# **Appendix M**

## Response to Comments

# Responses to Comments

This appendix to the Final Environmental Impact Report (EIR) for the Olive Park Apartments Project (project) includes a copy of all comment letters that were submitted regarding the Draft EIR (Draft EIR), along with responses to comments in accordance with California Environmental Quality Act (CEQA) Guidelines Section 15088. The 45-day review period for the Draft EIR began on October 25, 2024, and ended on December 9, 2024.

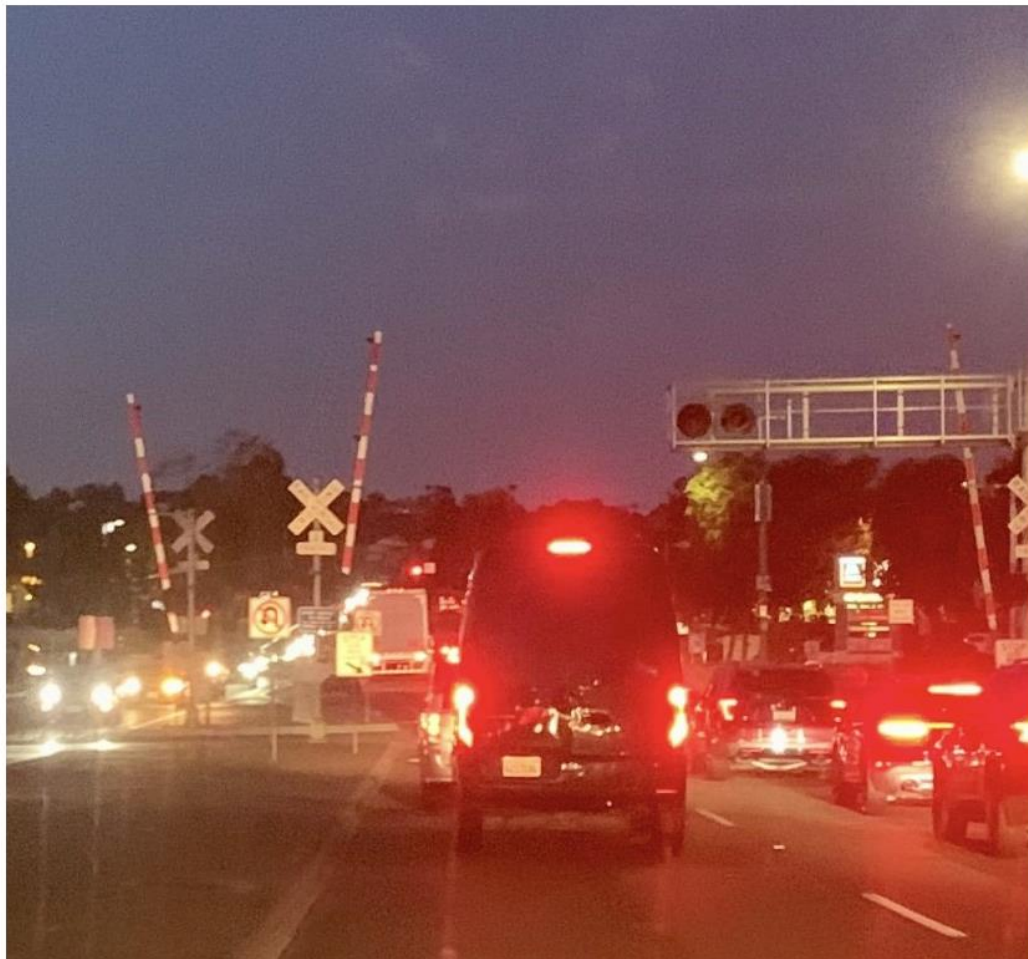
I-14-3  
Cont.

I-14-3  
Cont.

I-14-3  
Cont.

I-14-3  
Cont.

Megan Ley, DEIR Comments for Olive Park Apartments

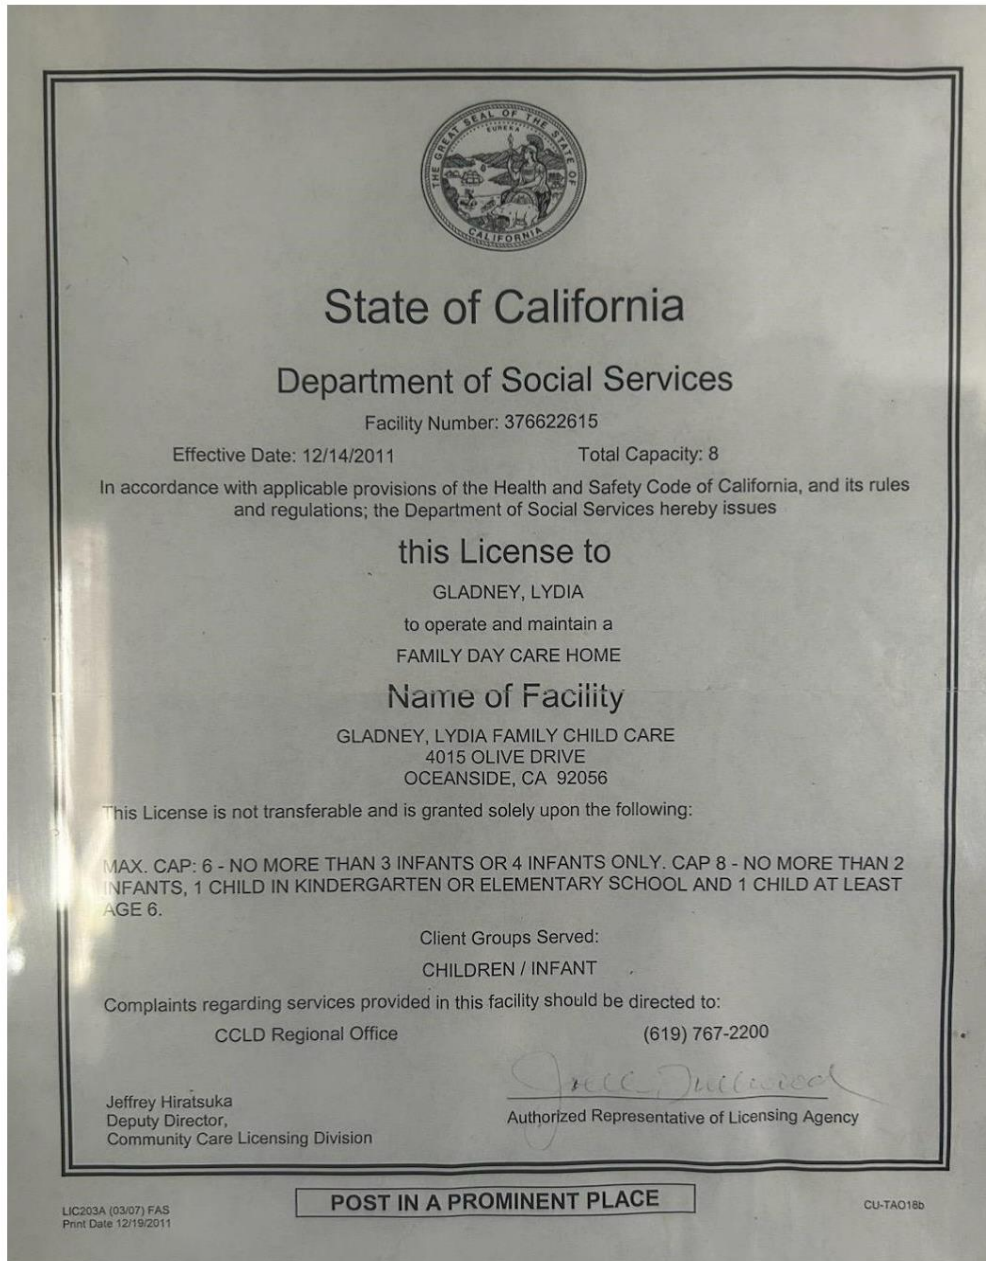
I-18-43  
Cont.
